# City of Orting Planning Commission Agenda

# **City of Orting Staff Report Planning Commission**

## City of Orting Staff Report Planning Commission

# City of Orting Staff Report Planning Commission

Glacier West Storage ADR 2022-06 Signage

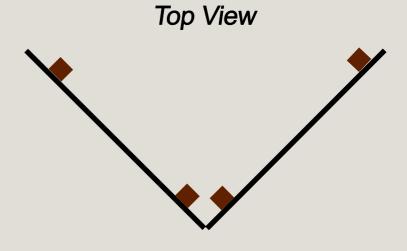
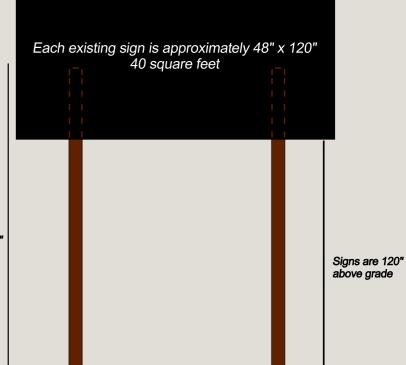
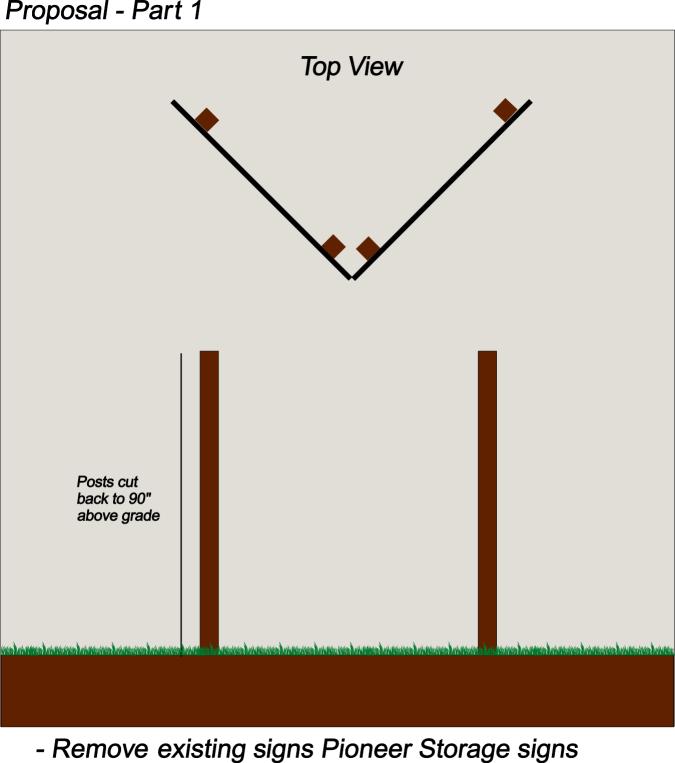
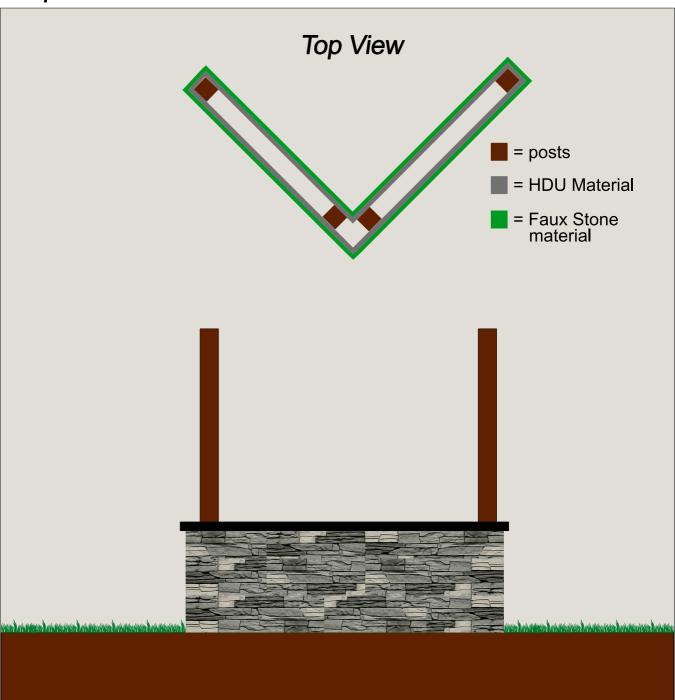
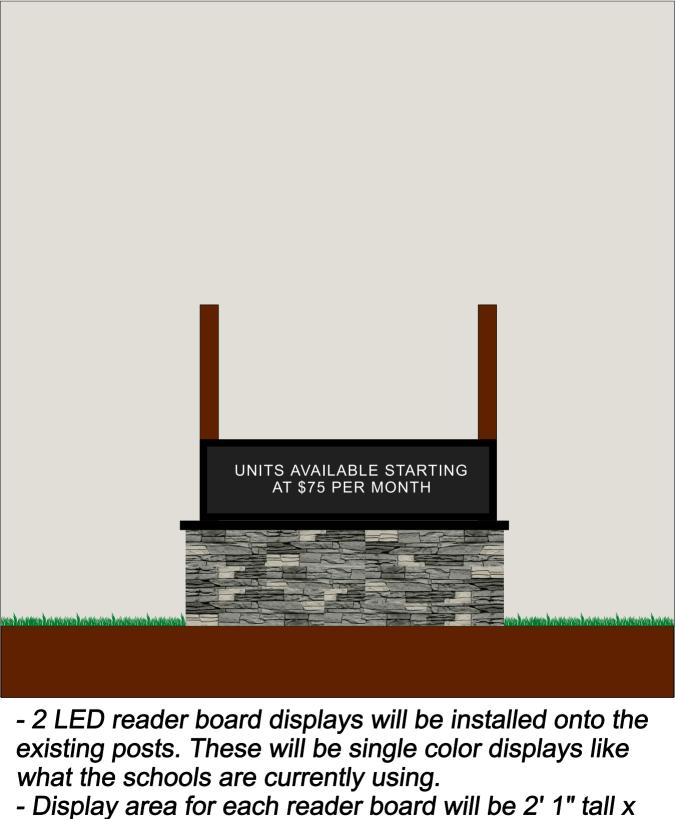
- 1. Grant a variance for the non-electronic portion of the freestanding commercial sign advertising Glacier West Storage. OMC 13-7-9 (A) states that properties that have between 200 and 300 feet of frontage along a right of way shall not have freestanding signs that exceed 5 feet in height. Based on the fact that Pioneer Way only serves local traffic and the purpose of the sign is to be visible from HWY 162, it is appropriate to grant a variance per OMC 13-7-10 (D) due to the to the limited view of the property and allow the sign height to be up to 8 feet tall based on the measurement standard prescribed in the definition of Freestanding Sign in OMC 13-7-2.

- 2. OMC 13-7-4 (L)(8) allows electronic signs in the MUTCN, MUTC and PF zones. Since the subject property is in the RUL zone an electronic sign is not permitted. The applicant has not articulated why a variance should be approved so staff do not recommend approval of the electronic sign.

- 3. The "Entering Cardinal Country" sign is a non-commercial sign and staff recommends its approval with the following variance per OMC13-7-10 (D): due to the limited view of the property a variance should

be approved to allow the top of the sign to be up to 6 feet tall based on the measurement standard prescribed in the definition of Freestanding Sign in OMC 13-7-2.
